RECALL R22CB

7.3L SHIFT CABLE-GASOLINE FUEL LINE INTERFERENCE

Models Affected: Certain 2022 & 2023 Model Year Blue Bird Vision Buses equipped with 7.3L Gasoline engine

Fig 1

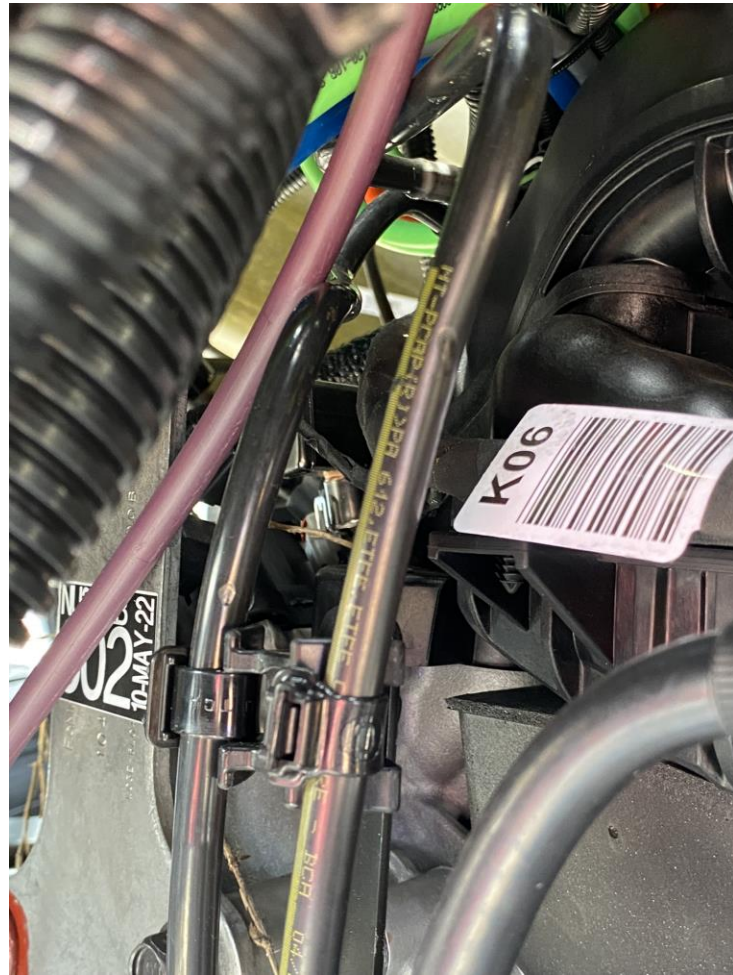
Step 1: Inspect the left rear corner of the engine from the top, and the bottom. If there is greater than 3” of clearance between the shift cable and the fuel line, no further action is required. Ref. Figure 1 for an example of insufficient clearance. If <3” of clearance, proceed to step 2.

Fig 2

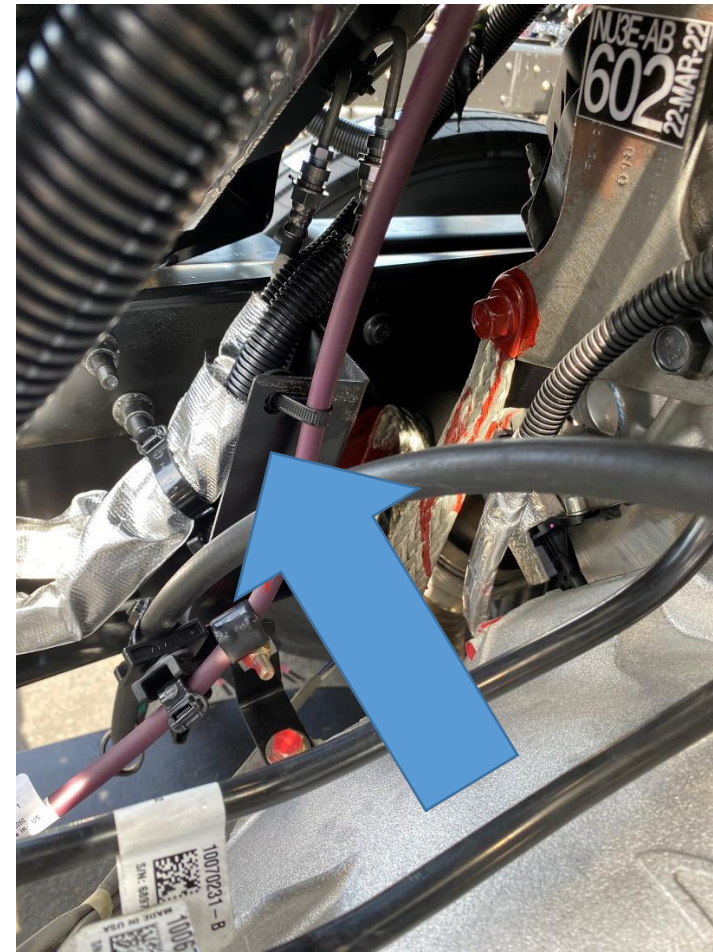
Step 3: Verify the heat shield bracket (Item 2), regardless of brake type is in place. Reference Figure 2. If missing, install per Figure 3.

Fig 3

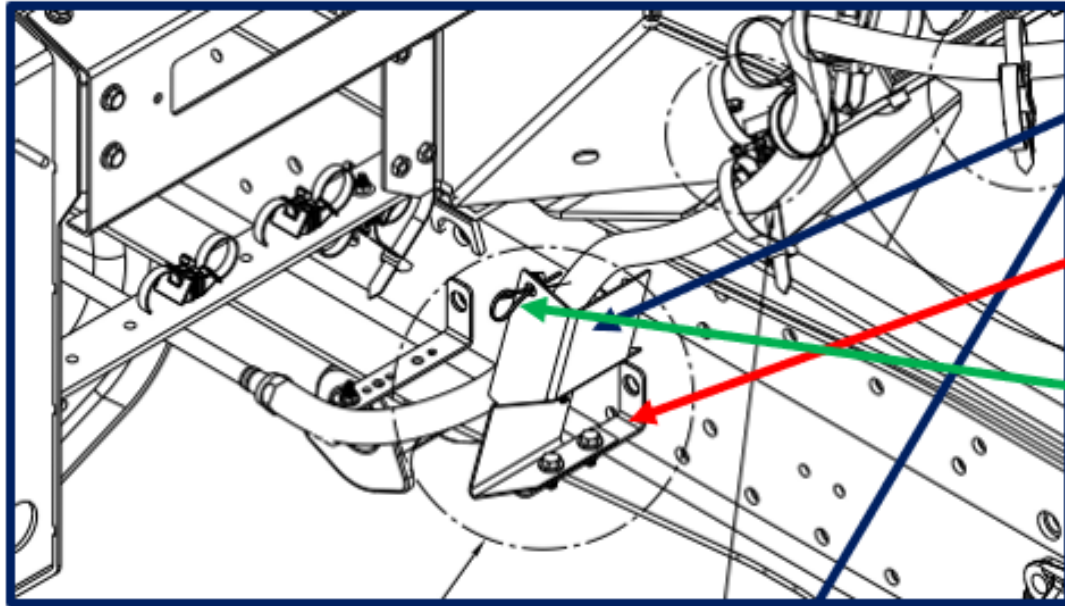
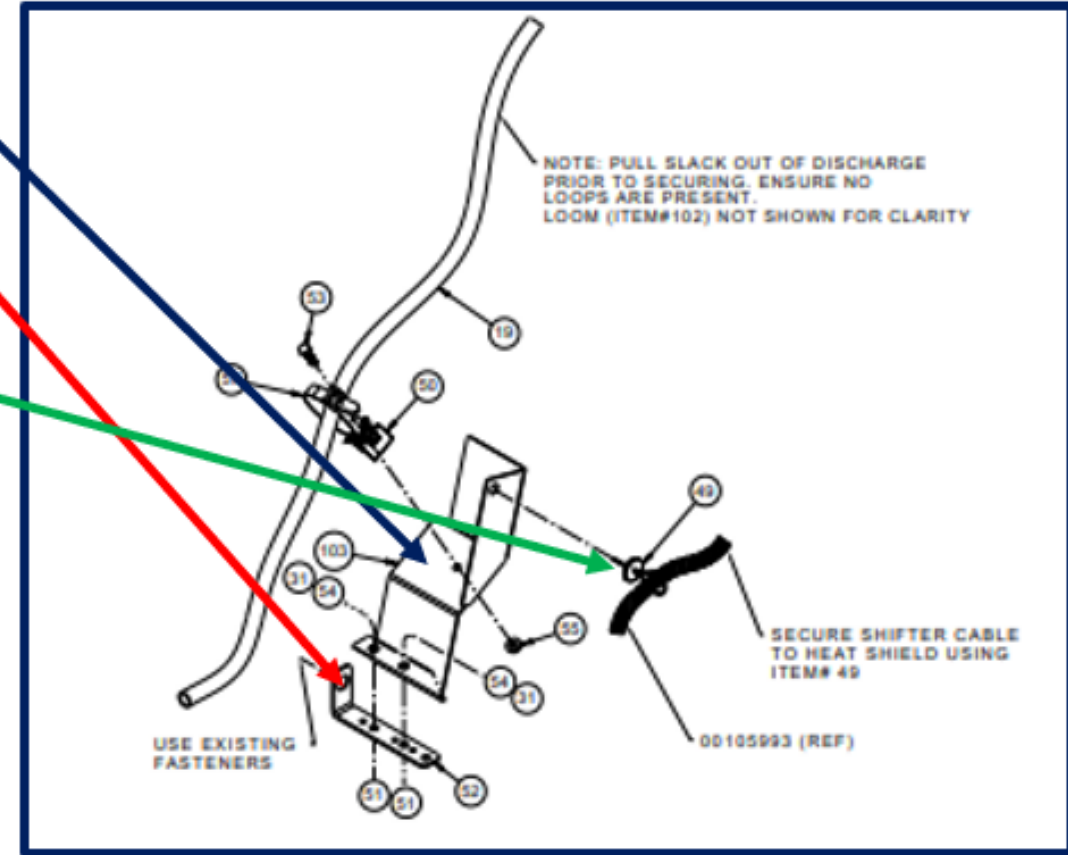
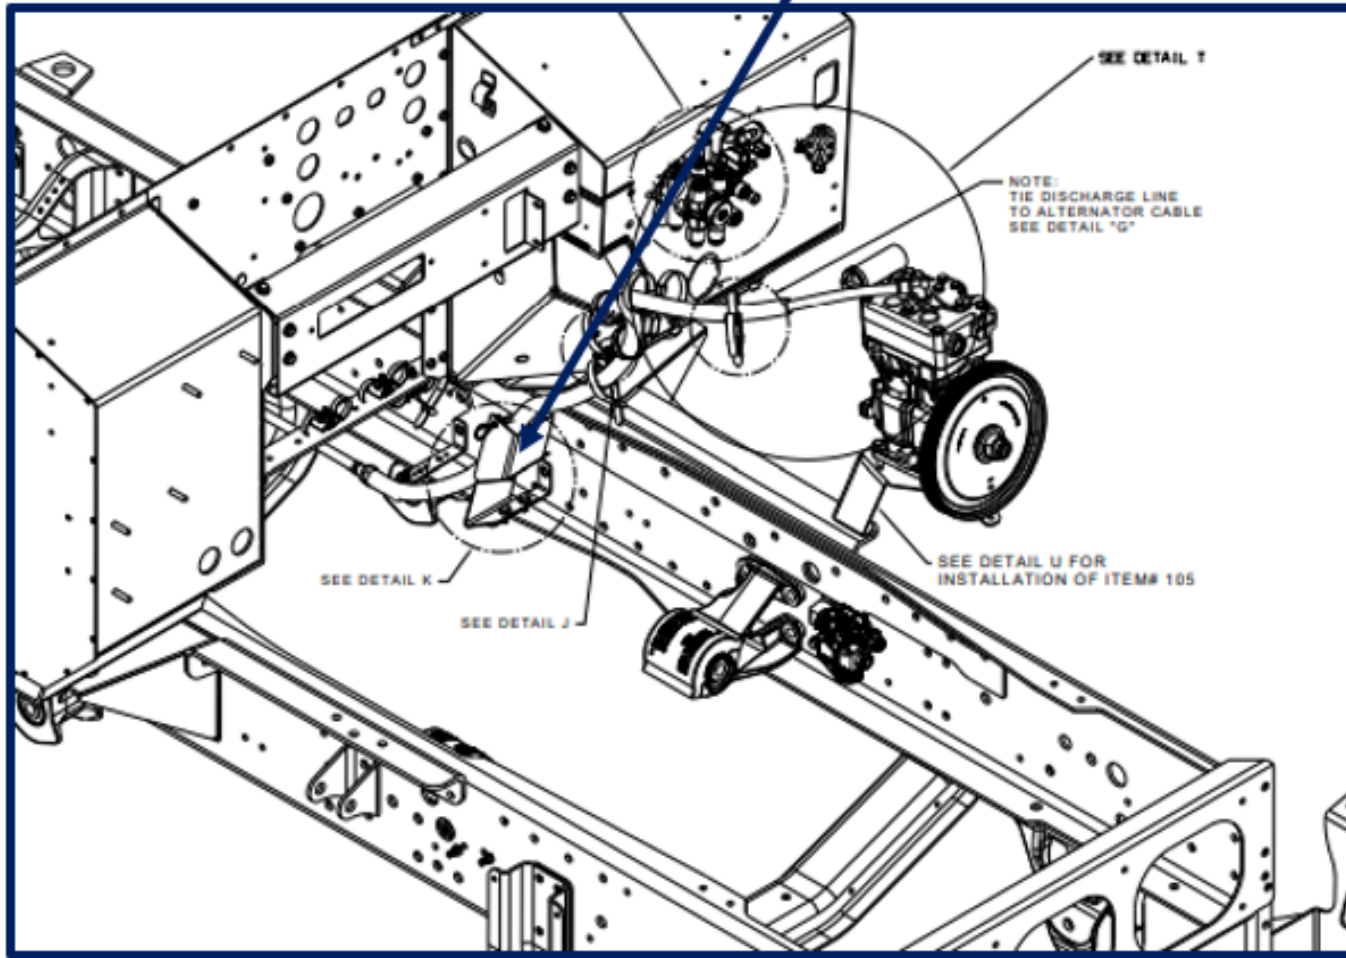
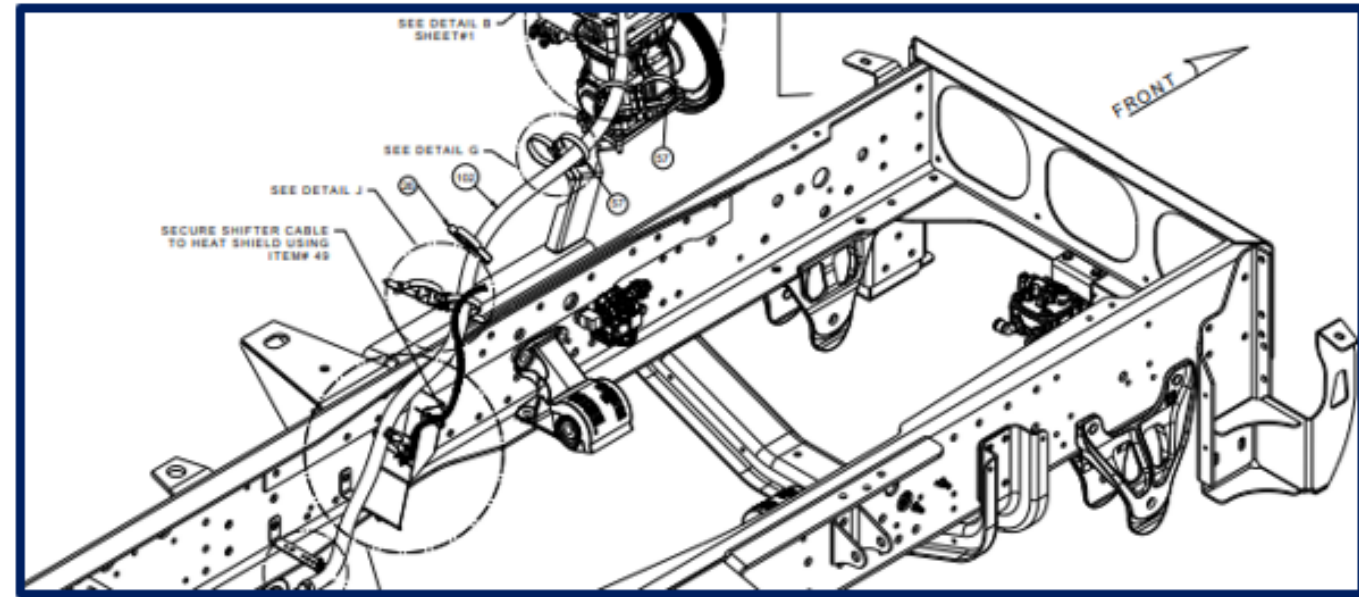
Step 4: Verify shift cable is routed properly and secured to the bracket with the HD button cable tie, p/n 00024076 per Figure 3

SECURE SHIFTER CABLE TO HEAT SHIELD USING ITEM# 49

SECURE SHIFTER CABLE TO HEAT SHIELD USING ITEM# 49

Fig 4

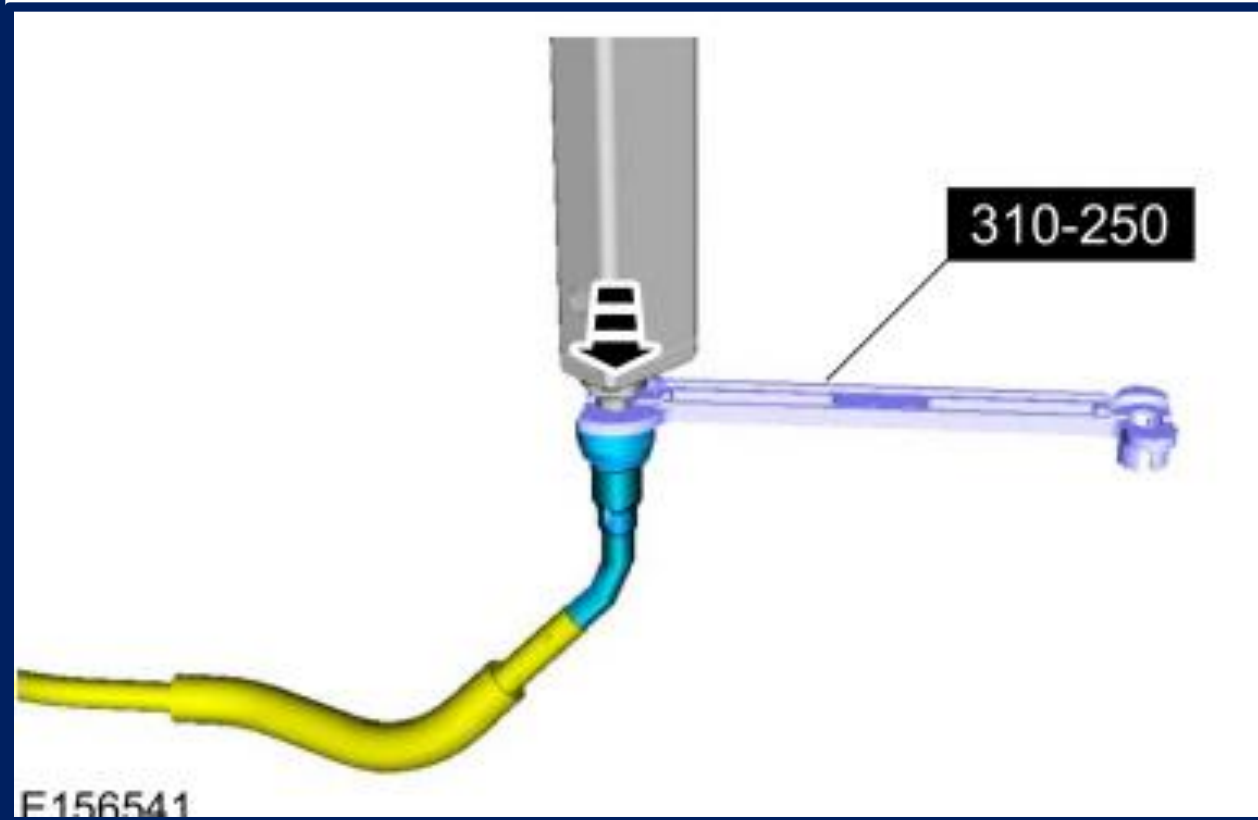
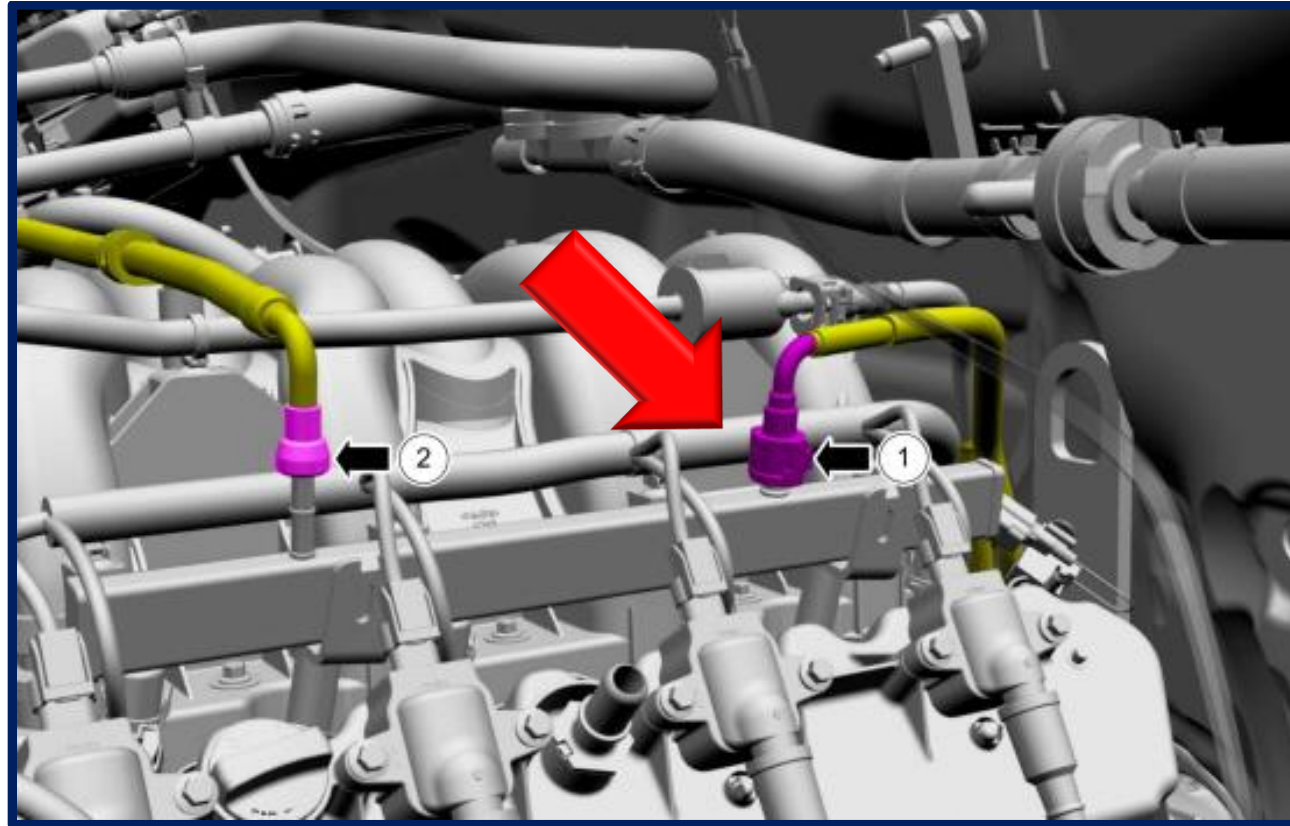
D- Wearing appropriate PPE, lay an absorbent cloth below the fuel line connection at the fuel rail and slowly disconnect the fuel line using Rotunda 310-250 or equivalent. See Figure 4
